SR 509/Taylor Blvd Interchange

RE: SR 167 Puyallup to SR 509
 Tier II DEIS Review

RE: SR 167, Puyallup to SR 509 – Tier II Draft Environmental Impact Statement

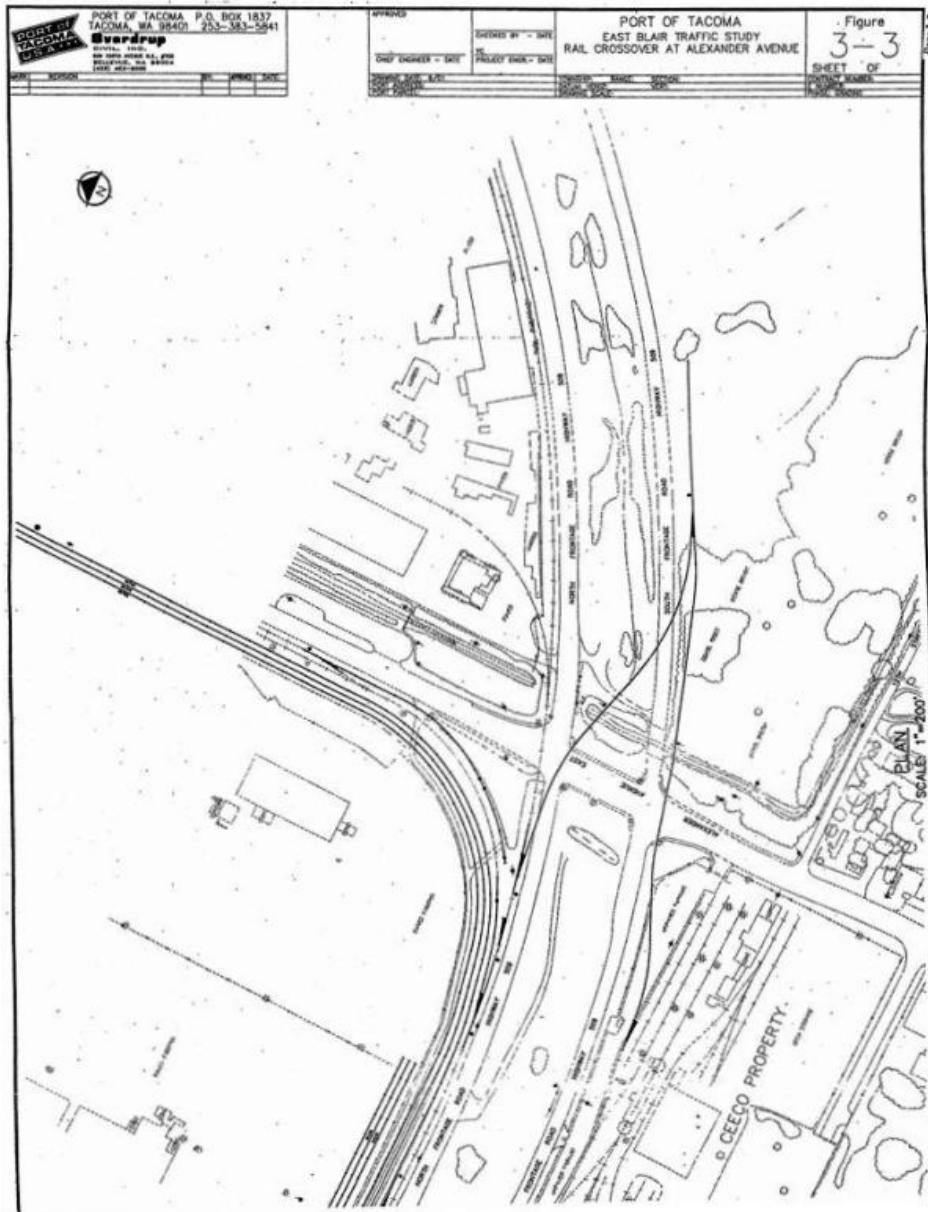
There currently exists an "at grade" rail crossing of SR 509 just west of Alexander Avenue. A grade separated rail corridor for access to the Ceeco property is not considered in this DEIS. The proposed rail trackage will cross near the proposed siting of the southbound ramp SR 509 to SR 167 and will need to cross under the elevated SR167 near Alexander Avenue. The ramp design will need to consider the rail right-of-way and the elevated SR167 roadway needs to consider the railroad required 'envelope' dimensions. As this project moves from the EIS towards design, the Port will want to remain involved in the design of the area of the SR 167 connection to SR 509 with regards to potential encroachment on rail trackage in this immediate area. We have provided a proposed rail configuration plan as part of this response for your review.

WSDOT and the Port has been working together to develop a rail crossing into the CEECO property. Please also see the "Rail Operations" section in section 3.14 of the FEIS.
